1	INC DCN ISID2-35-4 PER DCR 01-1685	SBV	
2	INC DCN ISID2-35-2 PER DCR 00-1786	"INITIALS ON FILE"	
3	INC DCN ISID2-35-1 FOR DCR 91-0011	"INITIALS ON FILE"	
4	ISSUED FOR SECOND 10 YEAR ISI PROGRAM	"INITIALS ON FILE"	
DATE	REVISION	BY	CHK'D
DAVIS-BESSE NUCLEAR POWER STATION UNIT NO. 1			
INSERVICE INSPECTION DIAGRAM SPENT FUEL POOL COOLING SYSTEM			
ISID2-035		3

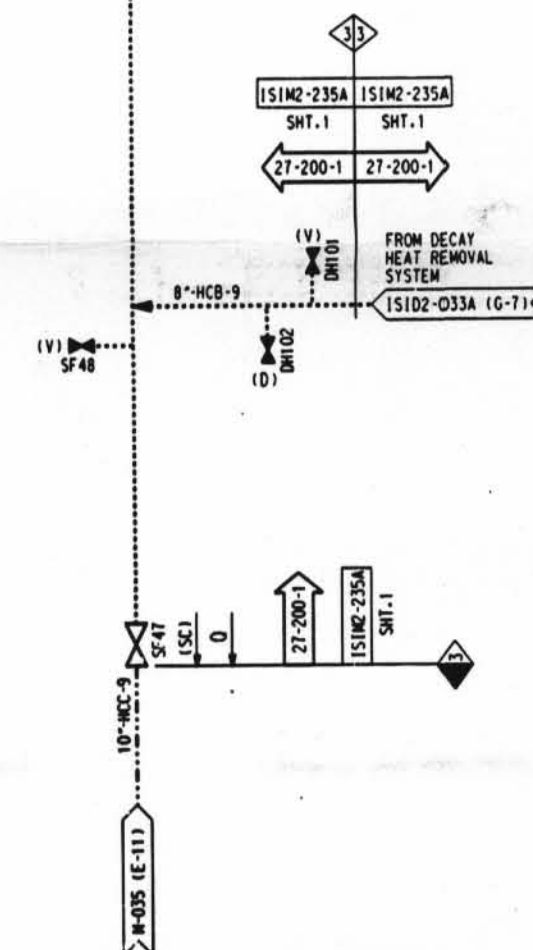
INFO. NOTE:
(REMOVE AT NEXT UPDATE)
REVISION CHANGE IN THE CLOUDED
AREA WAS FOR COLORIZING THE
SPENT FUEL POOL AS GREEN
